SI - SDA STAGE - Stage Inspection Report

Email Report To:	info@articon.com.au
Report Number:	APCI01531
Inspection Date:	08 Feb 2024
Address of the Property Inspected:	lot 8735/84 Barham Way Spring Mountain 4300 Queensland Australia
Photo of Property

Inspection Type: Frame

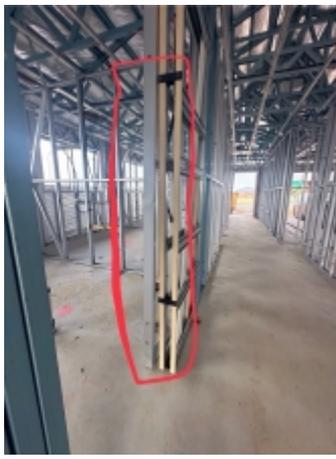
Loose/unsecured wall frame to the bathroom, additional support required to prevent the wall from the lateral movement. Recommend engaging a builder for further advice on repairs to prevent possible deterioration of the building.

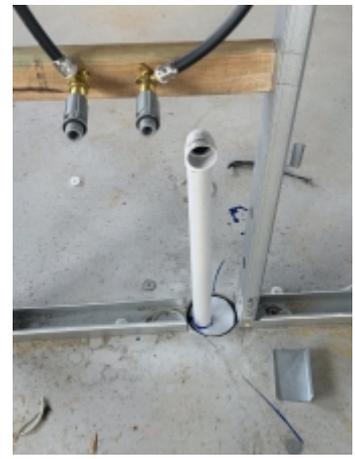
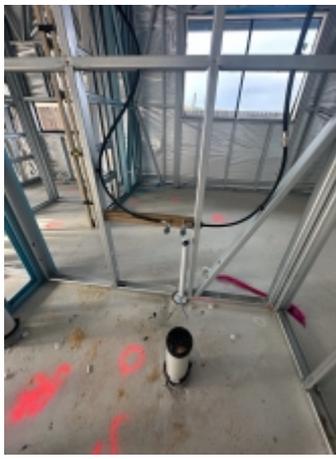
Discontinues- NON- loadbearing walls

Bottom plates in internal non-loadbearing and non-bracing walls may be discontinuous up to 60 mm (cut or drilled) to permit installation of services provided that, at the discontinuity, the plates are trimmed or otherwise reinforced either side of the discontinuity to maintain the lateral and longitudinal integrity of the wall. AS1684.4 - 6.2.1.4

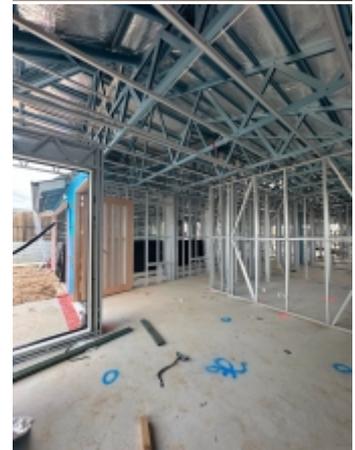
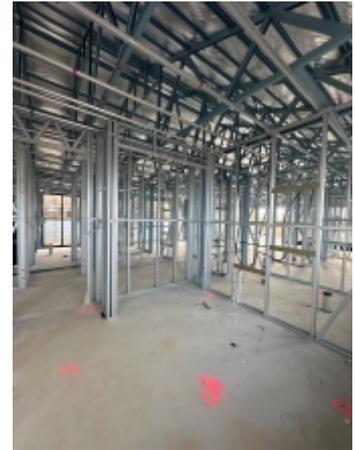
Missing Flashing/Facia to parts of front right side of the building. Recommend engaging a roofer for further advice on installation.
